Subject: **Response to Deficiencies in the Des Bee Dove Mine, Phase 2 Reclamation Plan, PacifiCorp, Des Bee Dove Mine, C015/017-AM01D-1, Emery County, Utah**

Title: Response to Deficiencies in the Des Bee Dove Mine, Phase 2 Reclamation Plan, PacifiCorp, Des Bee Dove Mine, C015/017-AM01D-1, Emery County, Utah

Attachment 1
Des-Bee-Dove Mines: Phase 2 Reclamation
Page 1 of 2

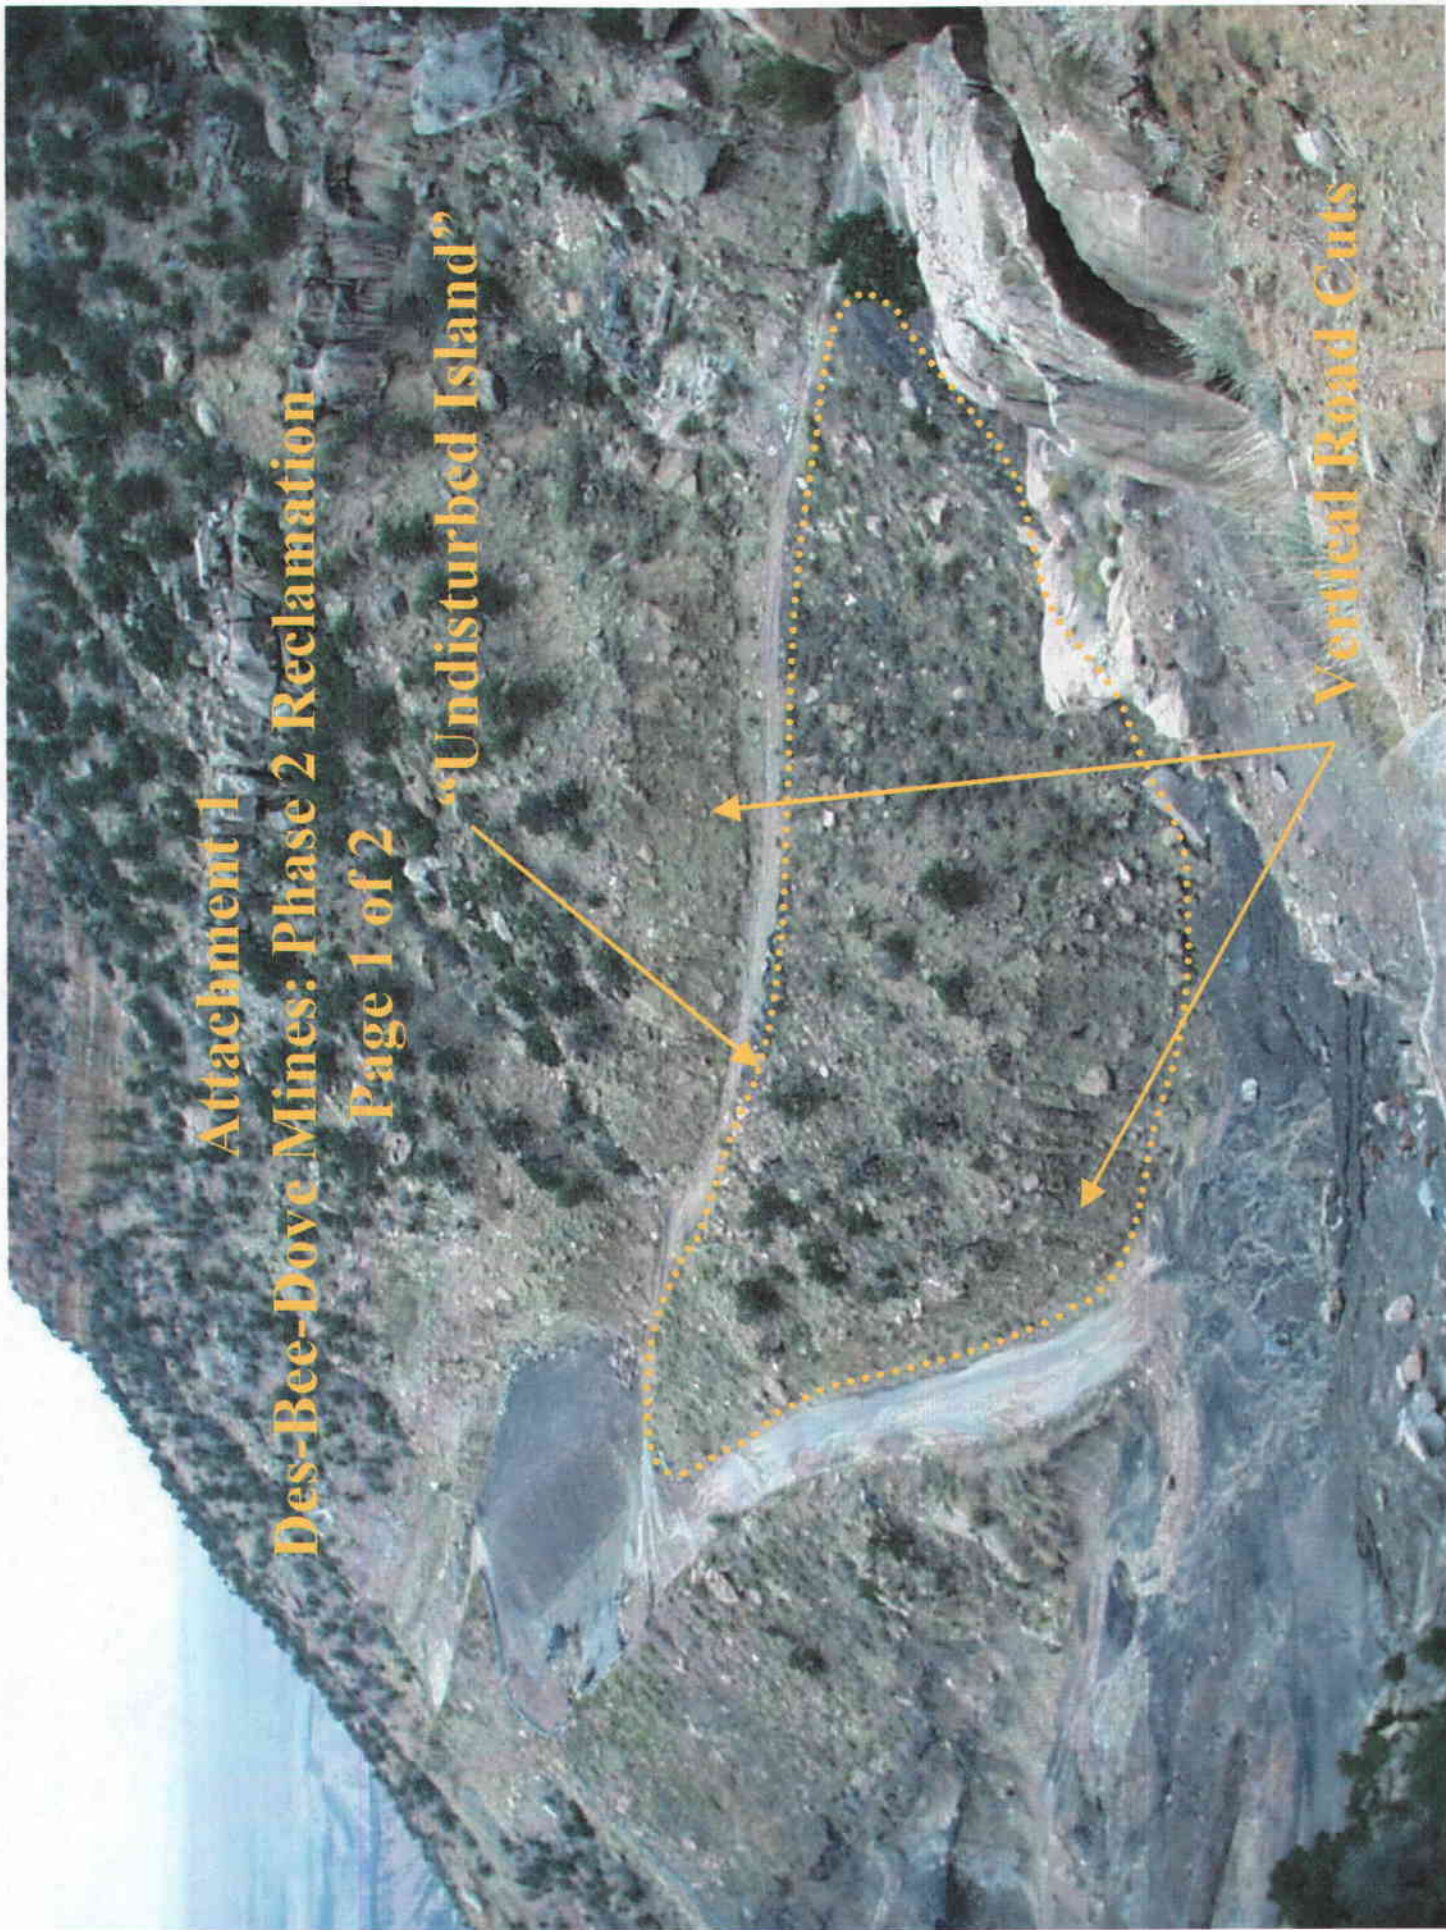
R645-301-232.200, (1) The submittal must describe separate handling (removal & storage) of the surface three feet of bathhouse outslope soils. (2) The submittal must indicate the Permittee's intention to utilize the undisturbed "island" south of the Tipple yard for substitute topsoil as a last resort after other alternatives have been exhausted and after consulting with the Division and obtaining the Division's concurrence. (3) The Permittee must evaluate increasing the area of substitute topsoil salvage from the southern portion of the bathhouse outslope.

(2) The permittee has conducted several scenarios to find the best topography to accomplish AOC and slope stability. Reviewing the cross-sections 9+00 through 11+00 on map 200-1 shows that the cut wall is being eliminated completely achieving AOC. Slope stability is maintained since the near vertical cuts are nearly eliminated.

If not eliminated and the "island" is left in place, the road cuts in this area would be regraded to a slope not to exceed 2:1. As these cuts will not be maintained after reclamation, the vertical cuts would potentially become unstable and fail. The exposed vertical cut on the bathhouse access road would be approximately 30 feet high by 150 feet long. An exposed cut would also be left on the Deseret portal access road. There are many potential safety issues associated with unstable cuts (refer to Attachment 1 - Phase 2 Reclamation photos).
